ZONING BOARD OF APPEALS APPLICATION

Project Name, If Applicable: FREEMAN RESIDENCE

PLAN REVIEW COMMENTS

DESCRIPTION OF WORK : Raise roof at bedroom over garage to create a long dormer to have a 7' 10" ceiling height.
(Change CH at edge of room from 5' to 7' 10")

SUMMIT AVENUE
 SITE PLAN
 1" = 15'-0"

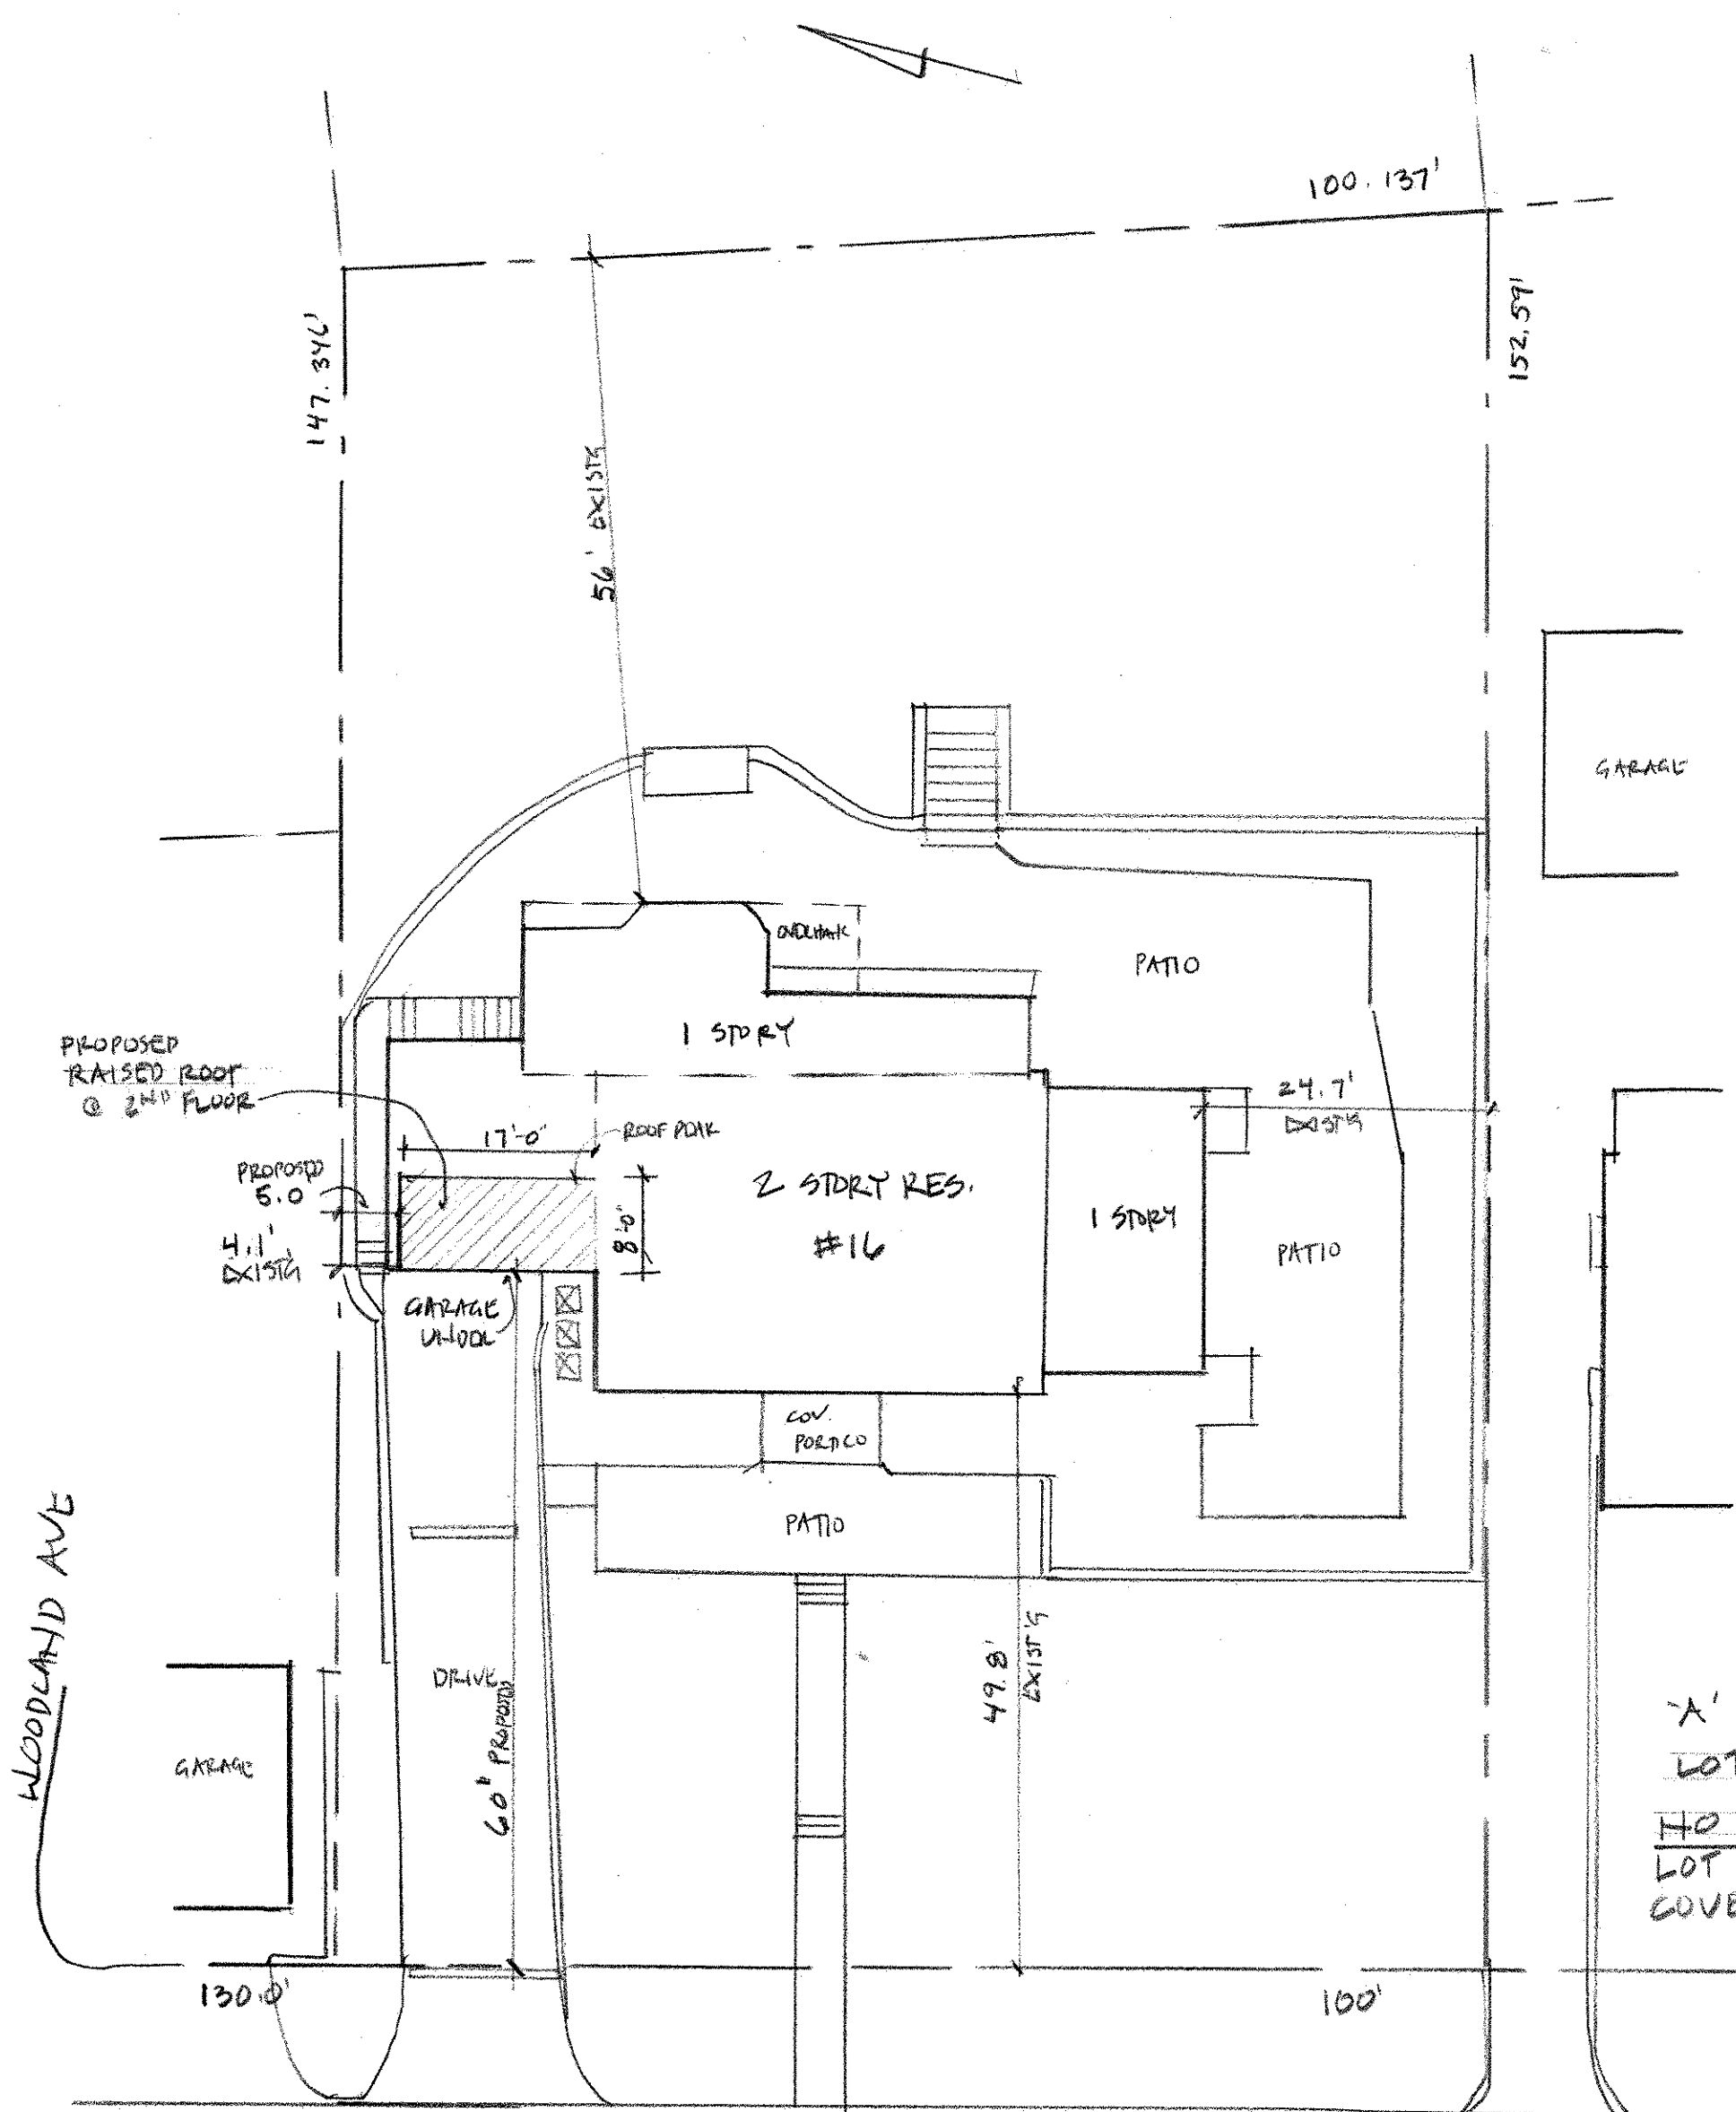
- 1) Pre-existing non-conforming side yard setback - Existing 4.1'; Proposed dormer - 5.0'; variance required - 10.1'
- 2) Compliance required for Village of Bronxville Municipal Code - 310-22 E (1) (d) - Dormer rule - dormer is greater than 30% of front
- 3) If #2 above is applicable, then a variance request for FAR may be required.
- 4) Building Permit Application hereby referred to Village of Bronxville Zoning Board of Appeals
Plan Review –

EXISTING GARAGE BELOW BEDROOM
TO REMAIN SAME 1/4" = 1'-0"

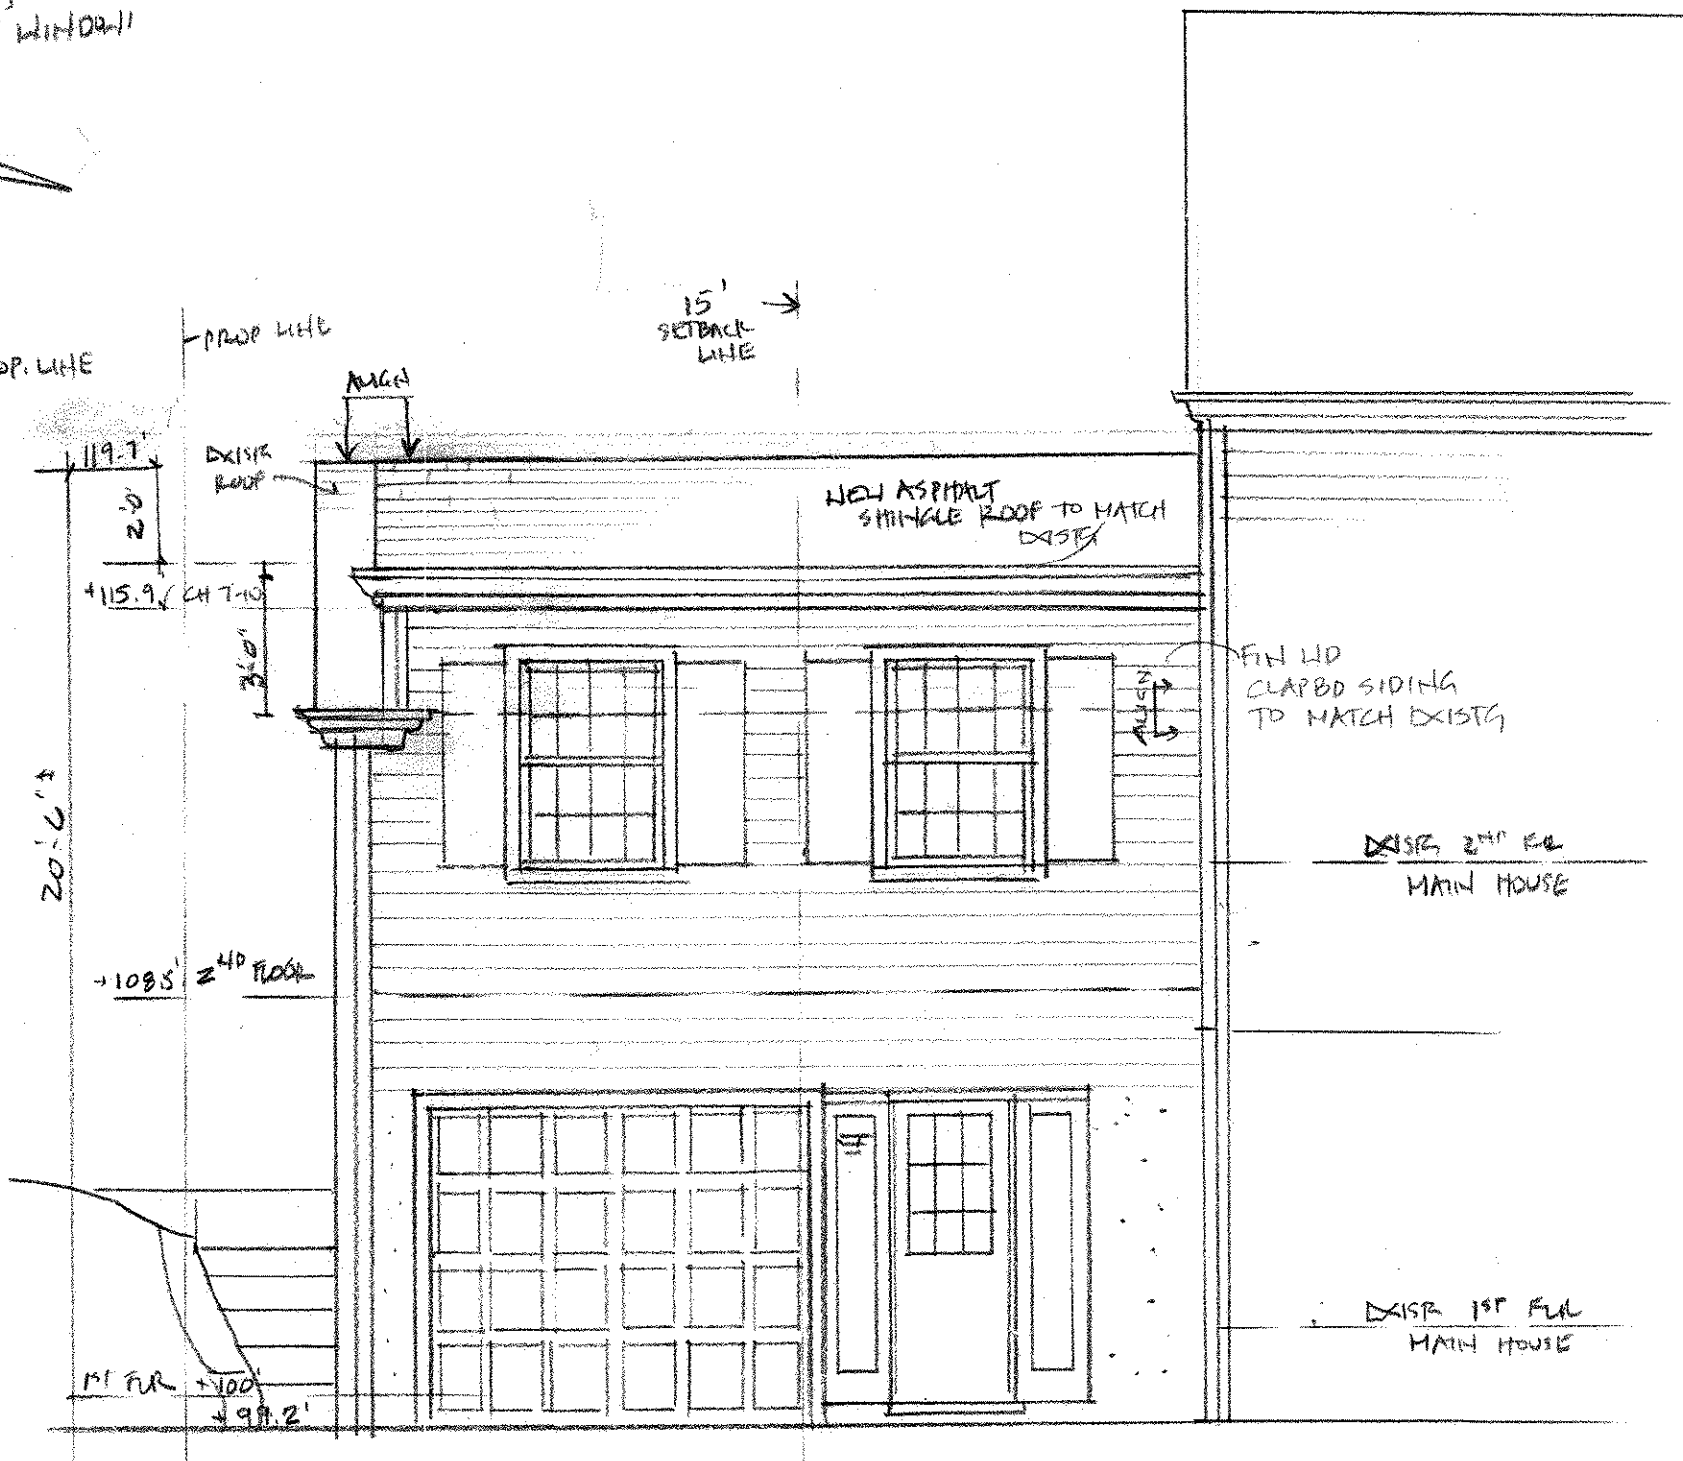
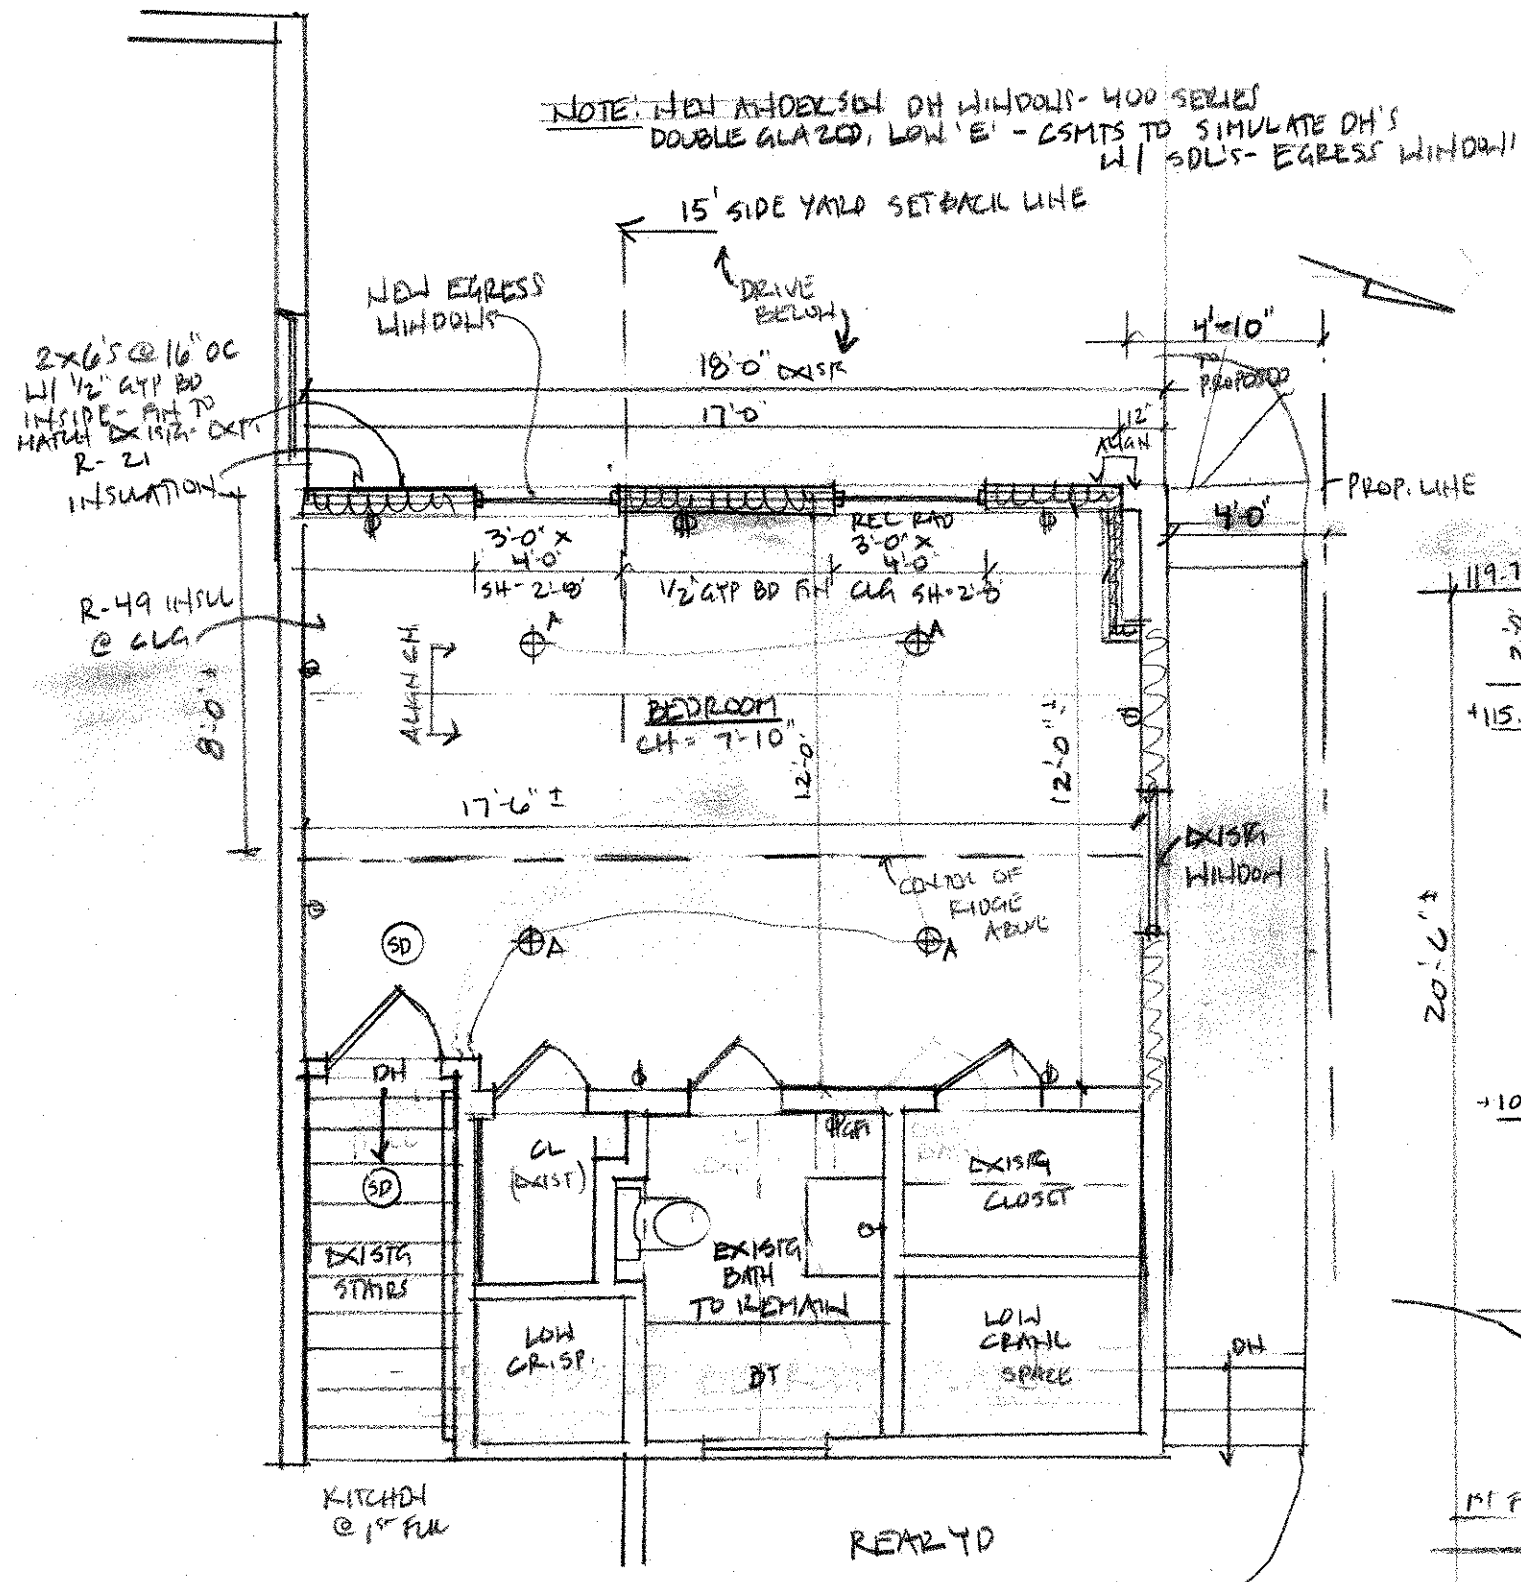
1) Provide full floor plans garage seems to be separate, possibly reversed?
